Access Compliance Report

Public Rights-of-Way

(Curb Ramps)

Intersection ID: 3051	Main Street: WHITE_STAG_DR	Cross Street: WHITE_STAG_DR	Location: NW
ADA ID: 4EF7B76F33D2	Ramp Type: Perp	Initial Pass/Fail: Fail	Overall Compliance: No
Severity Score: 60			
Codes/Mitigation Info/Possible Solution		Field Measurements/Component Compliance

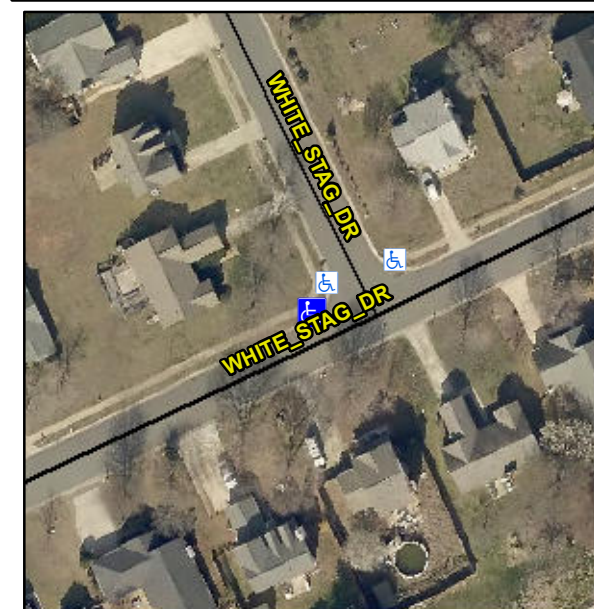
Not Found, R304.5.1, R304.2.2

Compliance	Description	Data	Compliance	Description	Data
N/A	Ramp Length (in)	46.0	No	Ramp Slope (%)	13.6
No	Ramp Width (in)	31.0	Yes	Ramp XSlope (%)	1.4
N/A	Flare Type LT	N/A	N/A	Flare Type RT	N/A
N/A	Flare Slope LT (%)	N/A	N/A	Flare Slope RT (%)	N/A
N/A	Flare Traversable LT?	N/A	N/A	Flare Traversable RT?	N/A
N/A	Landing Length (in)	N/A	N/A	DWS Provided?	N/A
N/A	Landing Width (in)	N/A	N/A	DWS Contrast?	N/A
N/A	Landing Slope (%)	N/A	N/A	DWS Length (in)	N/A
N/A	Landing X Slope (%)	N/A	N/A	DWS Full Width?	N/A
N/A	Landing Curb? (Y/N)	N/A	N/A	DWS Offset (in)	N/A
N/A	Shared Landing?	N/A			
N/A	Gutter Ponding?	N/A	N/A	Gutter Slope (%)	N/A
N/A	Gutter Lip Ht (in)	N/A	N/A	Gutter X Slope (%)	N/A
N/A	Painted X Walk1?	No	N/A	Painted X Walk2?	N/A
	X Walk 1 Direction	To S		X Walk 2 Direction	N/A
N/A	X Walk 1 Width (in)	N/A	N/A	X Walk 2 Width (in)	N/A
	X Walk 1 Slope (%)	2.5		X Walk 2 Slope (%)	N/A
	X Walk 1 X Slope (%)	0.4		X Walk 2 X Slope (%)	N/A

Remove & Replace Entire Ramp.
